To: T10 Technical Committee  
 From: Rob Elliott, HP (elliott@hp.com)  
 Date: 30 January 2005  
 Subject: 04-370r3 SAS-1.1 Merge IT and IR with XT and XR

### **Overview**

Figure 1 — External cable CT and CR compliance points

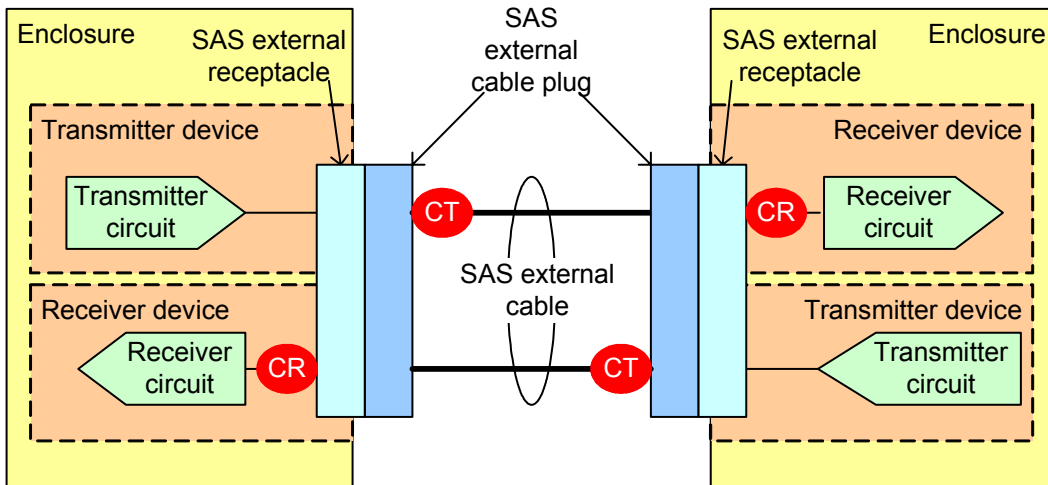
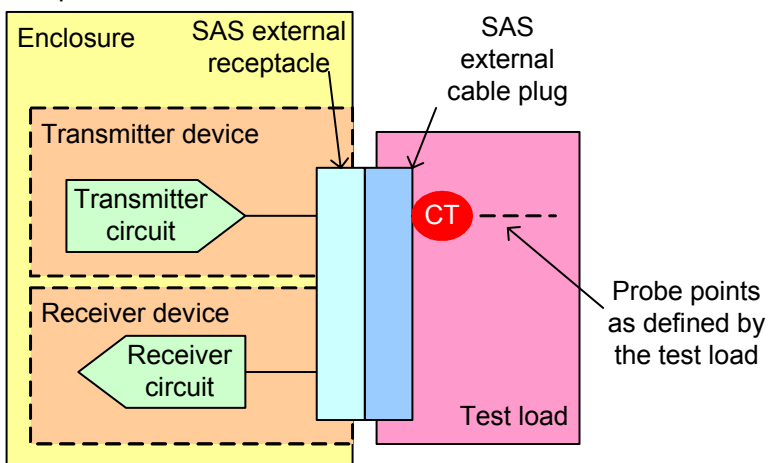
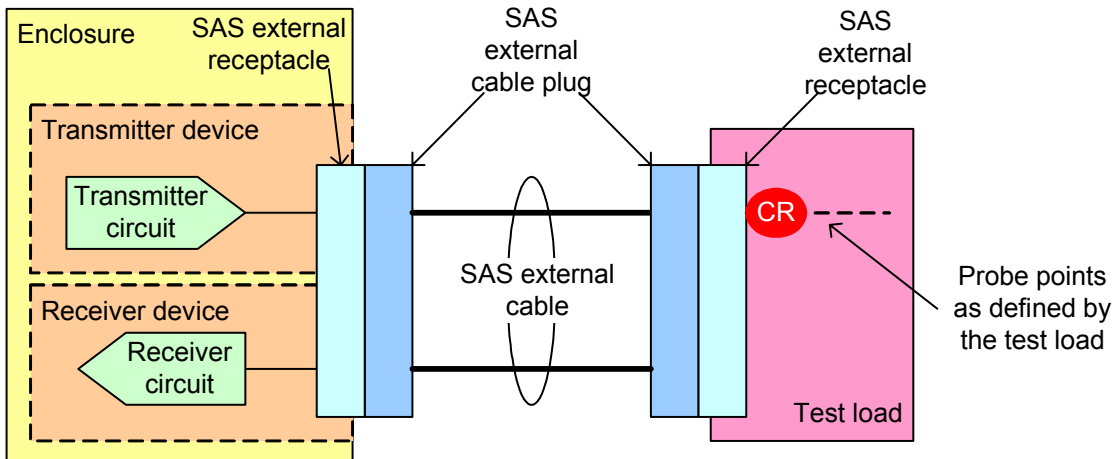
2. There is some confusion over where exactly the compliance points are located. Proposed figures are added showing the location of the compliance points for each type of connector interface and how the test loads are used to test compliance at those points.

Figure 1 shows the locations of the CT and CR compliance points using an external cable, and shows how two of the compliance points are tested using test loads with SAS external connectors (see figure 68 and figure 69 in 5.3.11).

Figure 2 — Backplane IT and IR compliance points

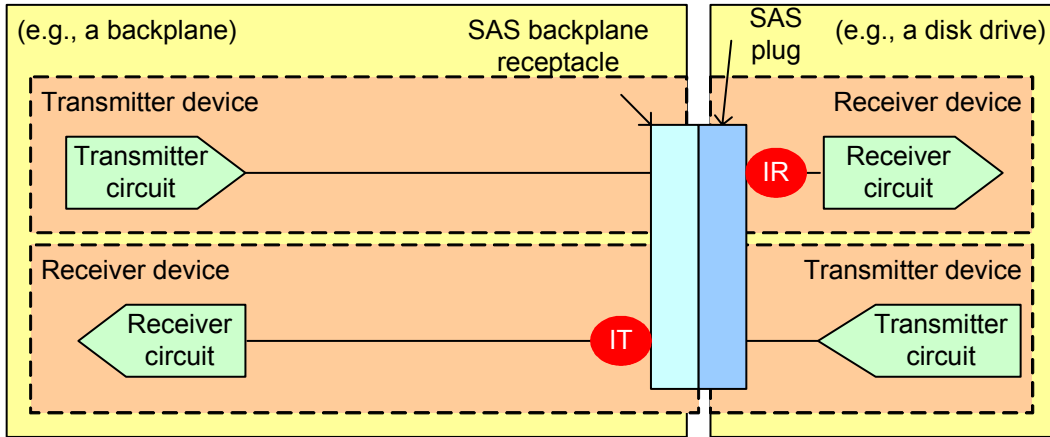
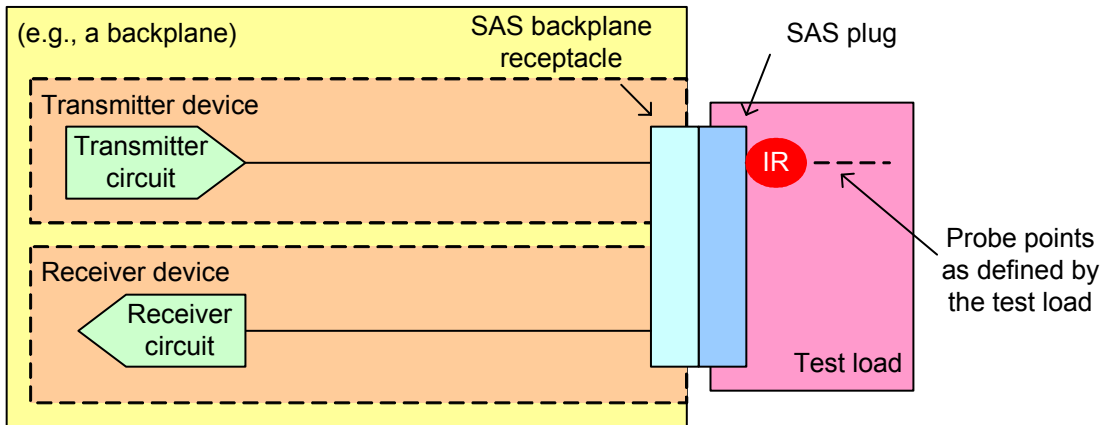
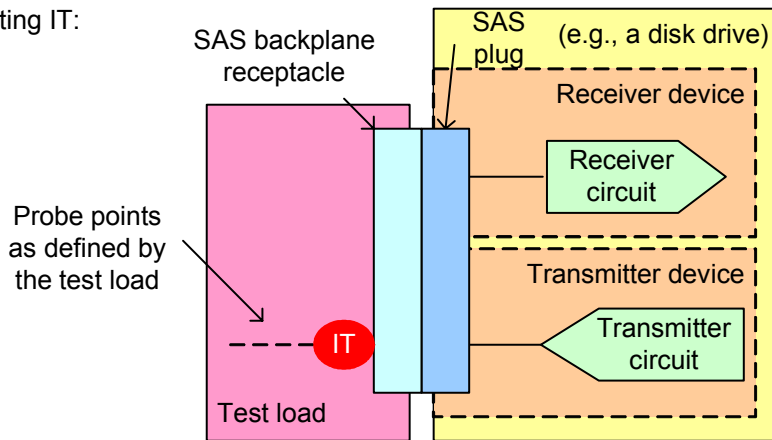
Figure 2 shows the locations of the IT and IR compliance points using a backplane with a SAS backplane receptacle (see 5.2.3.4) that is not attached to a SATA device, and shows how the compliance points are tested using test loads with SAS internal connectors (see figure 68 and figure 69 in 5.3.11).

Figure 3 — Backplane compliance points with SATA device attached

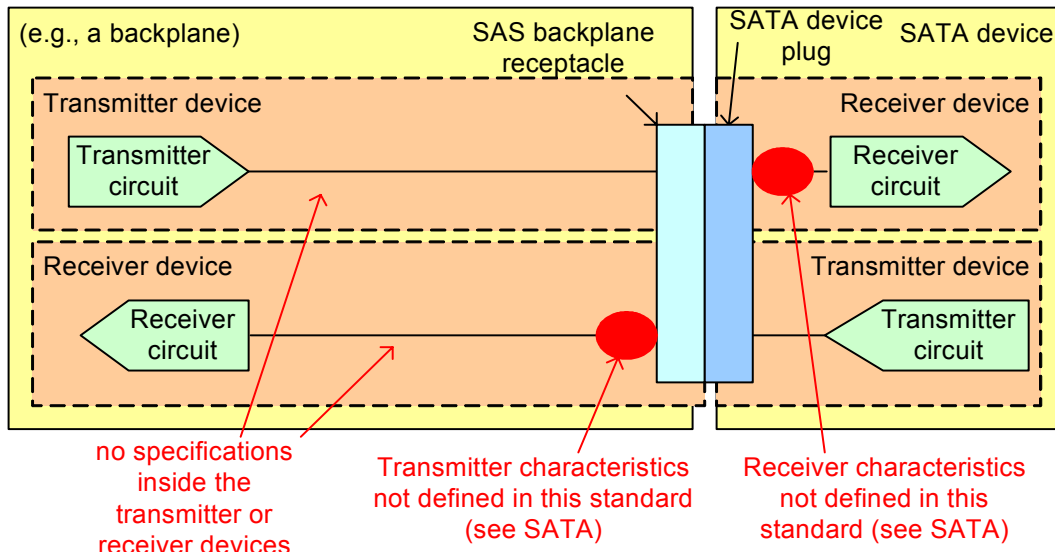
If the backplane supports SATA devices being attached to the SAS backplane receptacle (see 5.2.3.4), there are no IT or IR compliance points. SATA defines the signal characteristics that the SATA device delivers and that the SAS backplane is required to deliver to the SATA device, as shown in figure 3.

Figure 4 — Internal wide cable IT and IR compliance points

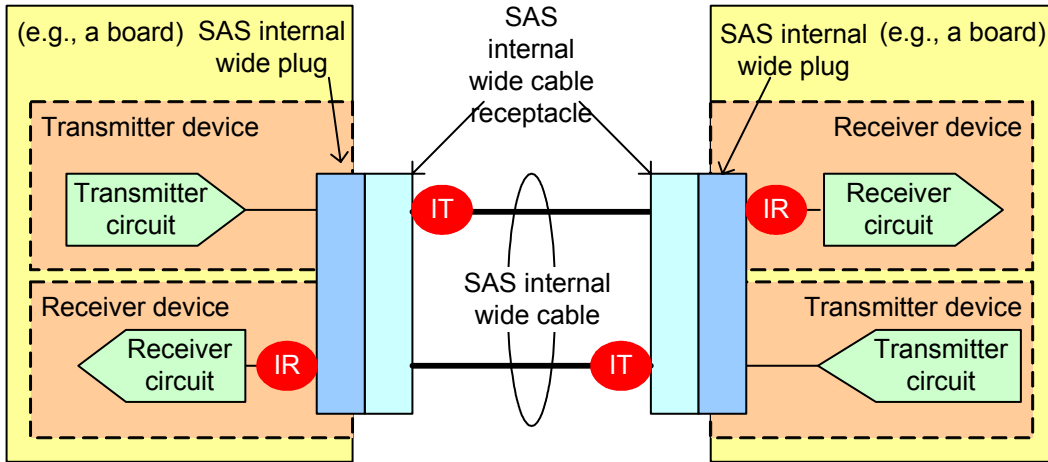
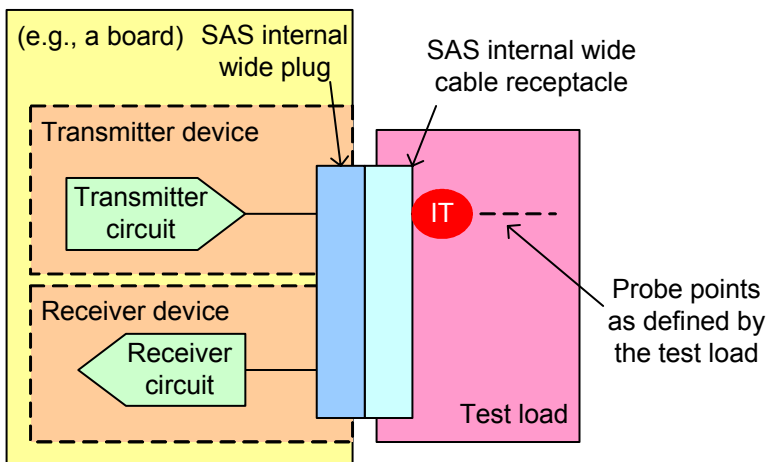
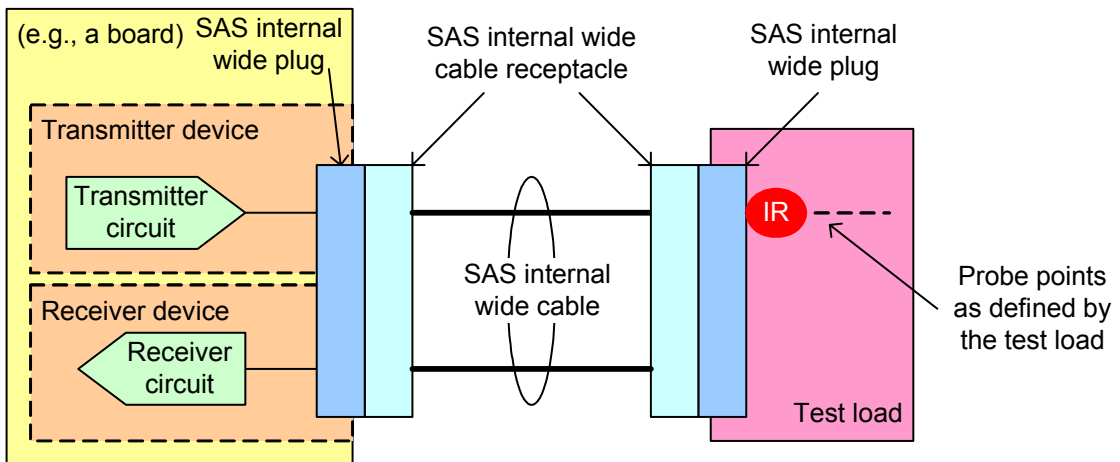
Figure 4 shows the locations of the IT and IR compliance points using an internal wide cable, and shows how two of the compliance points are tested using test loads with SAS internal connectors (see figure 68 and figure 69 in 5.3.11).

Figure 5 — Internal wide cable and backplane IT and IR compliance points

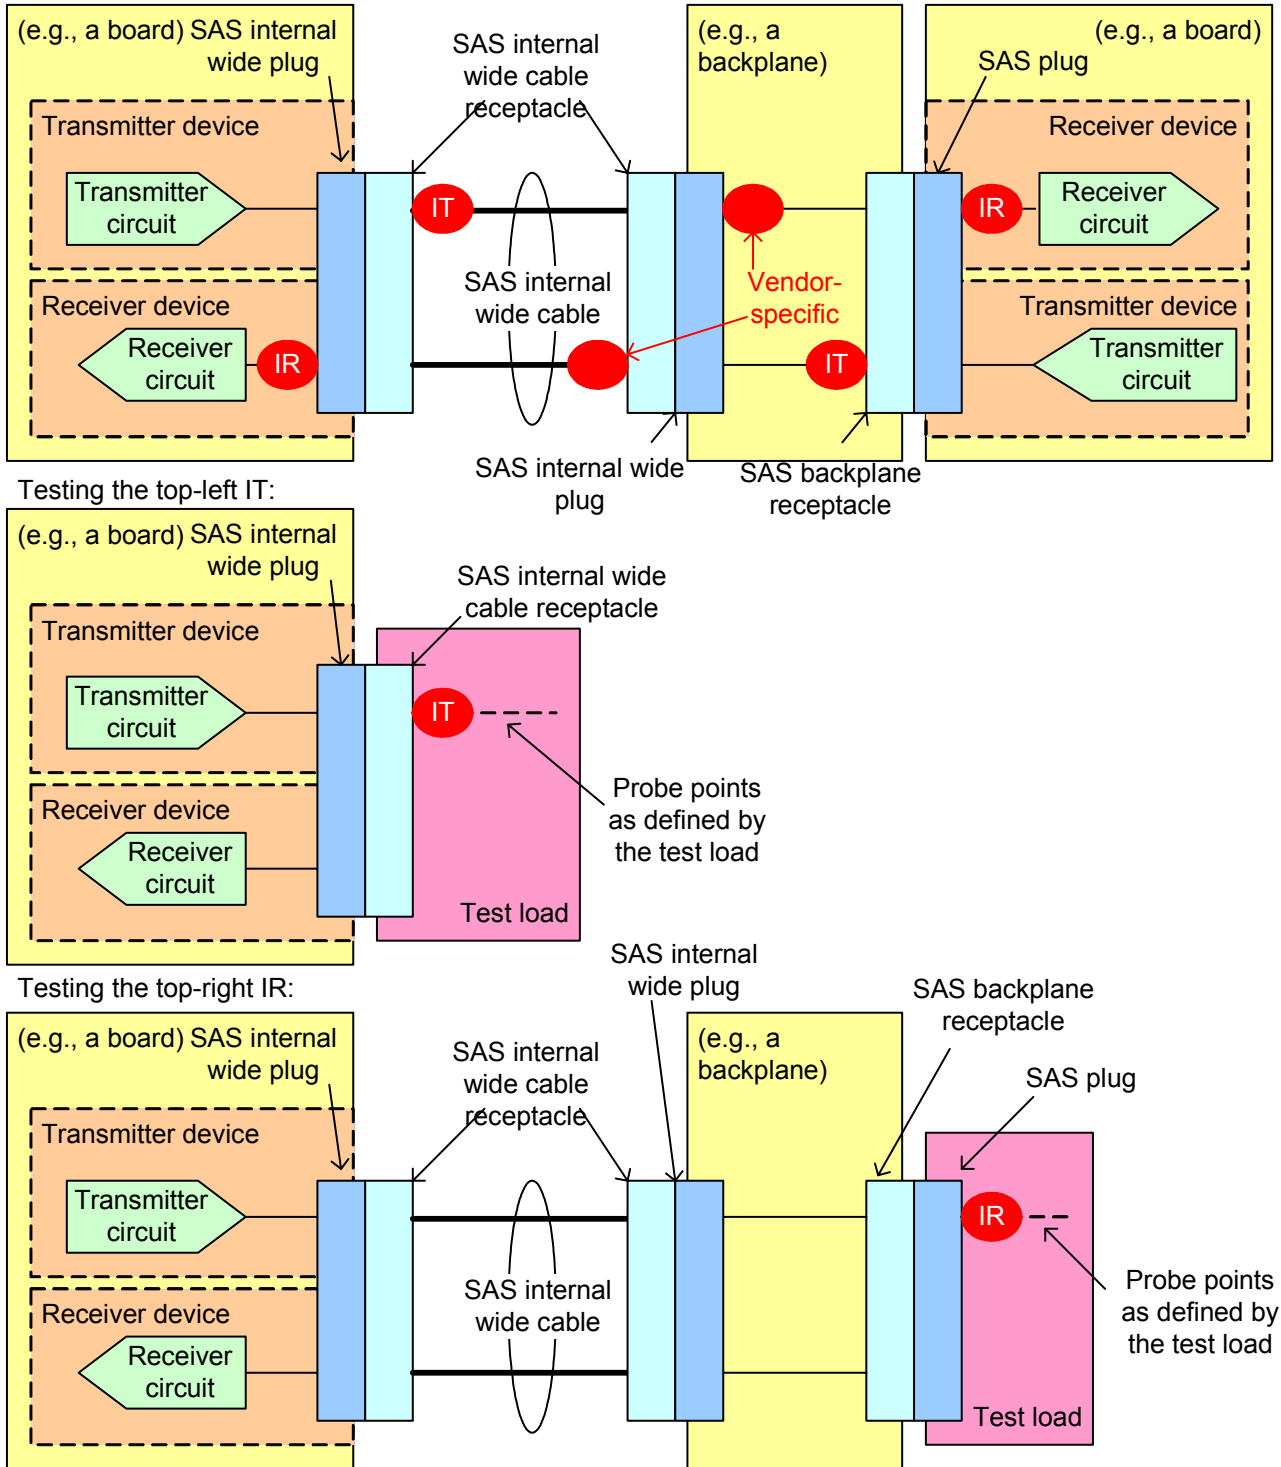
Figure 5 shows the locations of the IT and IR compliance points using an internal wide cable and a backplane, where the backplane is not attached to a SATA device. It also shows how two of the compliance points are tested using test loads with SAS internal connectors (see figure 68 and figure 69 in 5.3.11)

Figure 6 — Internal cable and backplane compliance points with SATA device attached

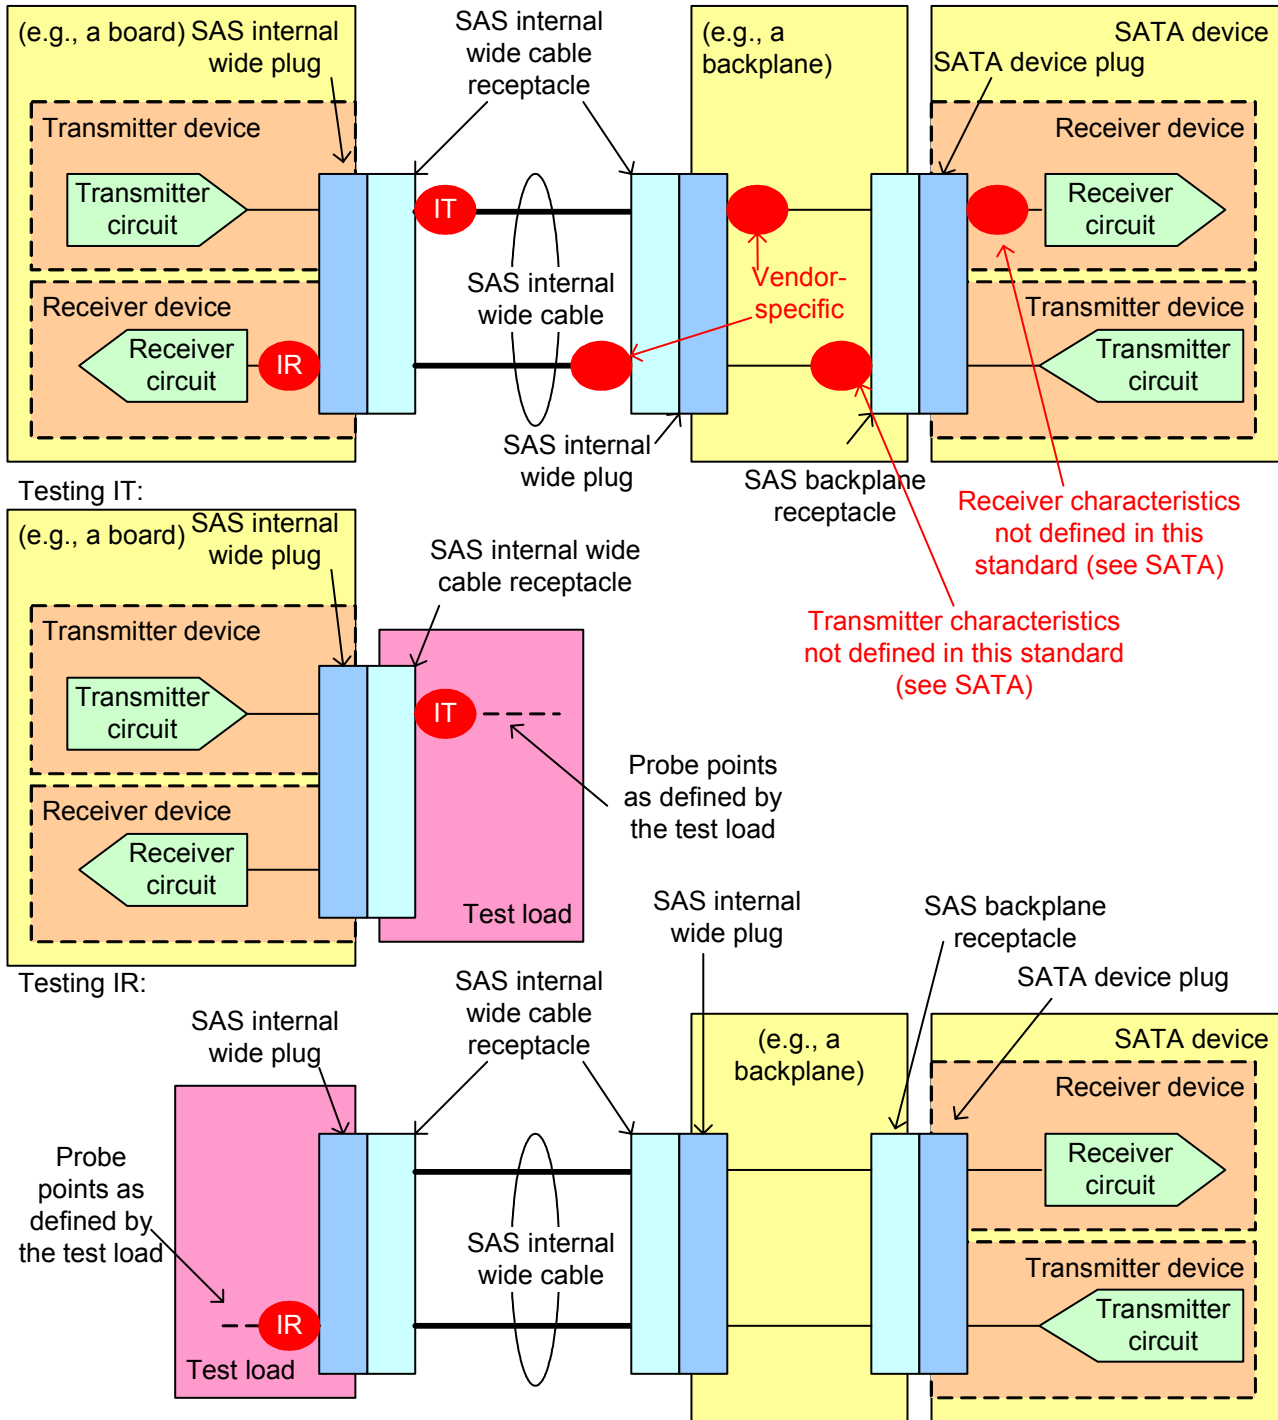
Figure 6 shows the locations of the IT and IR compliance points using an internal wide cable and a backplane, where the backplane supports being attached to a SATA device. There are no IT and IR compliance points at the SAS backplane receptacle connector when a SATA device is attached; SATA defines the signal

characteristics that the SATA device delivers and that the SAS backplane is required to deliver to the SATA device. There are compliance points at the internal wide connector, however.

Figure 7 — Internal cable IT and IR compliance points

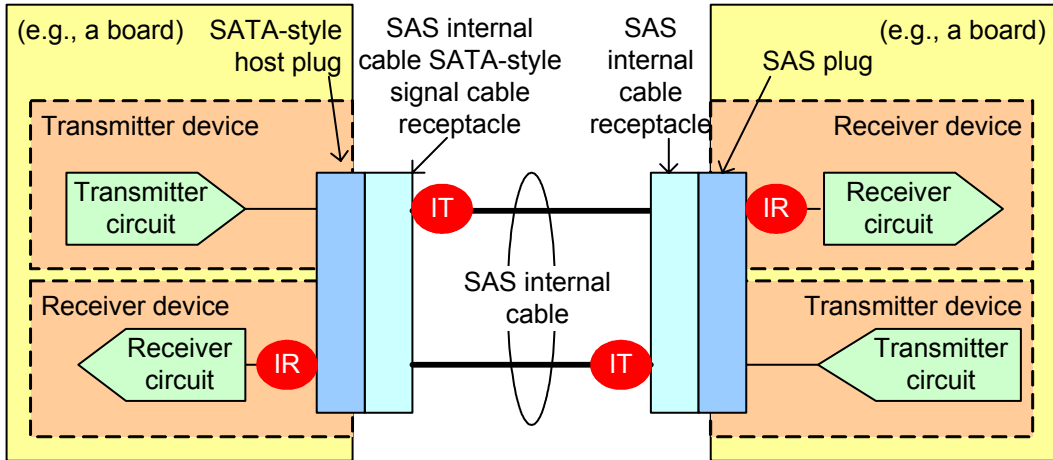
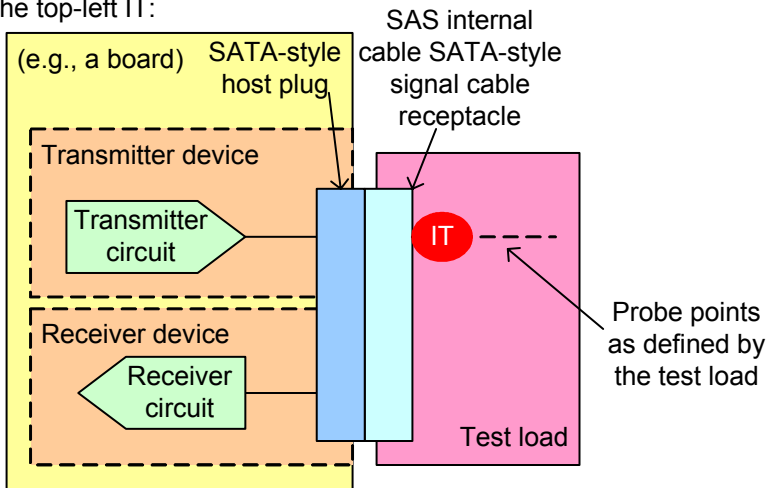
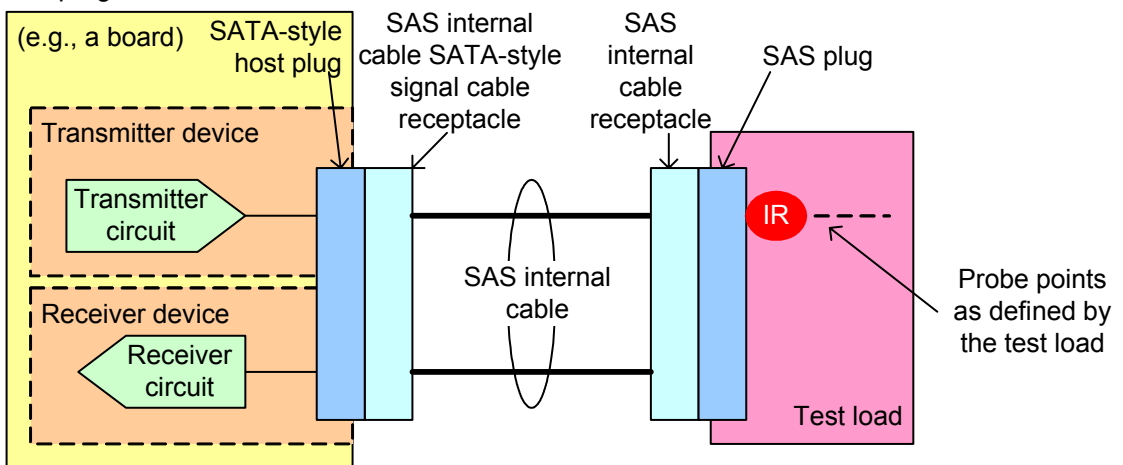
Figure 7 shows the locations of the IT and IR compliance points using an internal cable.

Figure 8 — Transmitter **device** transient test circuit

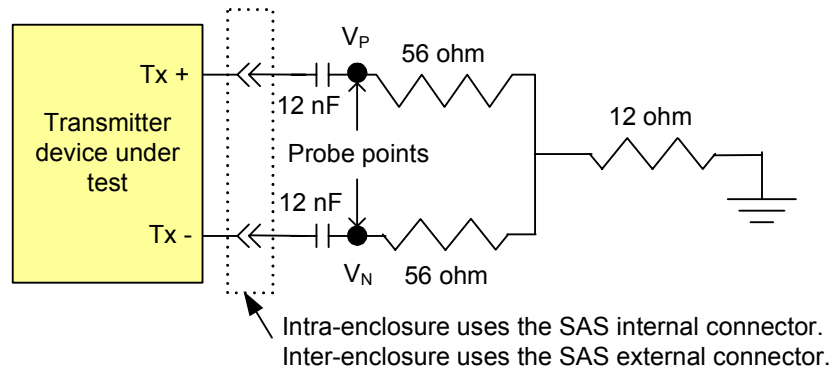
Figure 8 shows the **transmitter transient** test circuit [attached to IT or CT to test transmitter device transients](#).

Figure 9 — Receiver **device** transient test circuit

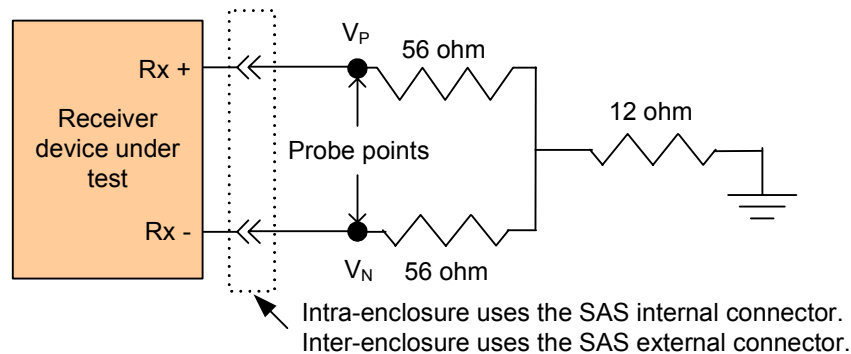
Figure 9 shows the **receiver transient** test circuit [attached to IT or CT used to test receiver device transients](#).

Figure 11 — ~~Eye mask at IR, CR, and XR~~ Receiver device eye mask

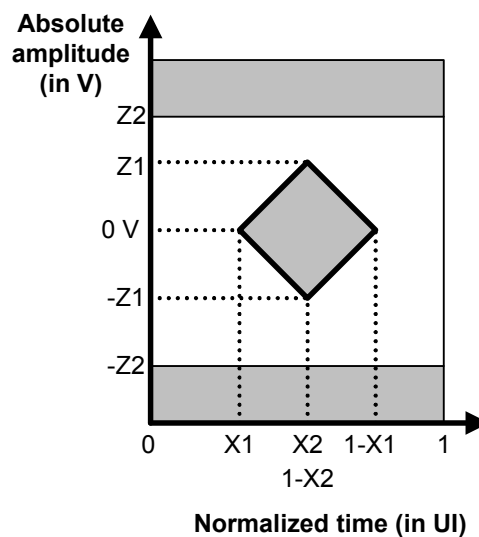
Figure 11 describes the ~~receive~~ eye mask ~~used for testing the signal delivered to the receiver device at IR and CR~~. The signal shall be measured using a jitter timing reference (e.g., a golden PLL) that approximates a single pole (i.e., 20 dB per decade) low-pass filter with corner frequency of  $((\text{bit rate}) / 1667)$ . This requirement accounts for the low frequency tracking properties and response time of the CDRs in receiver devices.
